**Millstone Nuclear Power Station, Unit No. 2
License Amendment Request - Unreviewed Safety Question
Proposed Revision to Final Safety Analysis Report
Radiological Consequences of Steam Generator Tube Rupture (PLAR 2-00-4)**

License Amendment Request - Unreviewed Safety Question
Proposed Revision to Final Safety Analysis Report
Radiological Consequences of Steam Generator Tube Rupture (PLAR 2-00-4)
Discussion of Changes and Safety Summary

License Amendment Request - Unreviewed Safety Question
Proposed Revision to Final Safety Analysis Report
Radiological Consequences of Steam Generator Tube Rupture (PLAR 2-00-4)
Marked Up Pages

FIGURE 14.6.3-8
STEAM GENERATOR TUBE RUPTURE
MAIN STEAM SAFETY VALVE FLOW RATE PER STEAM GENERATOR VS. TIME

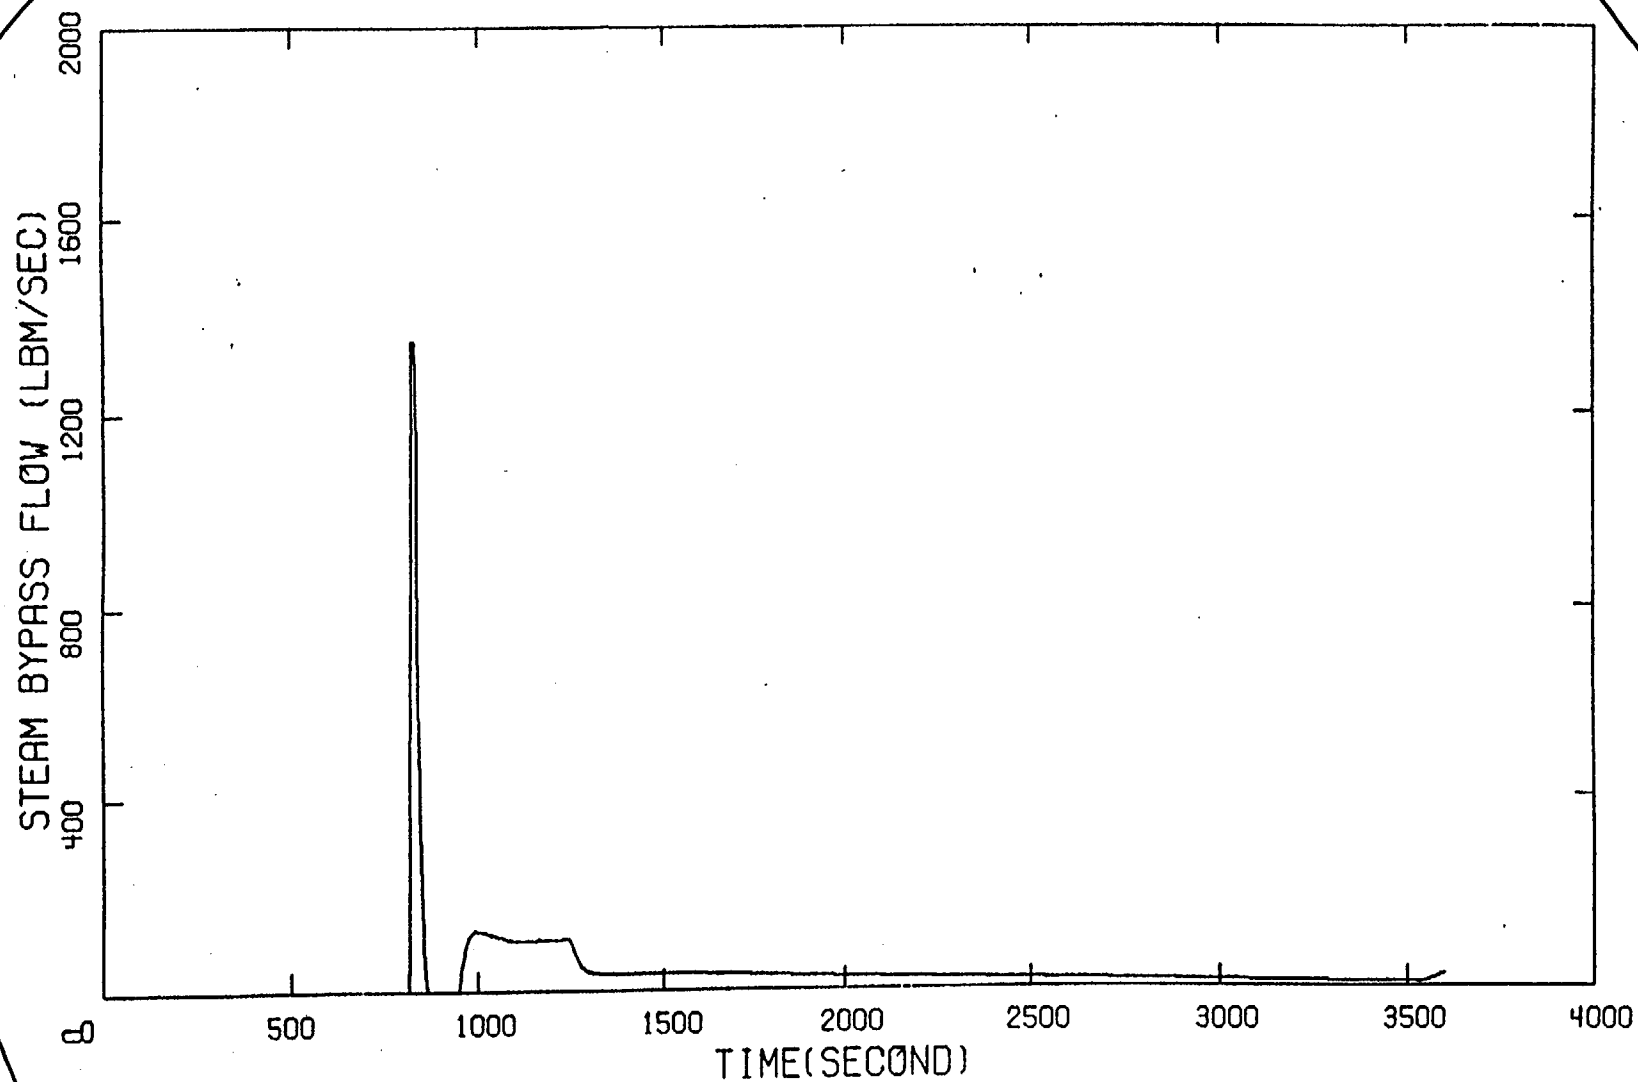
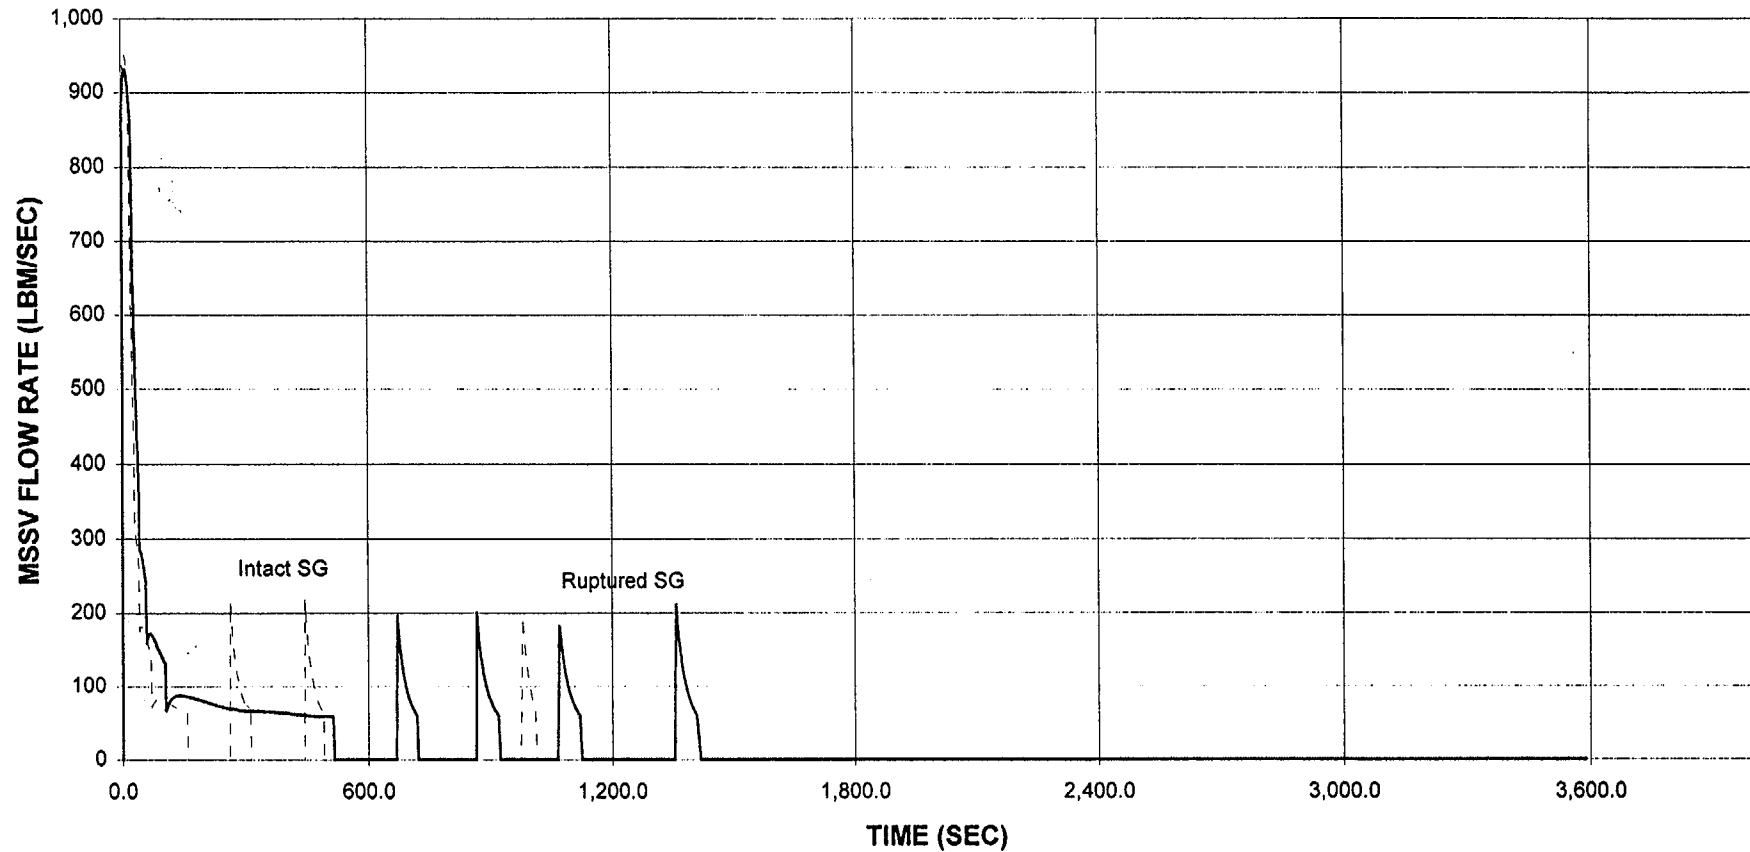
replace
with
next
page

MP2 SGTR WITH LOSS OF OFFSITE POWER
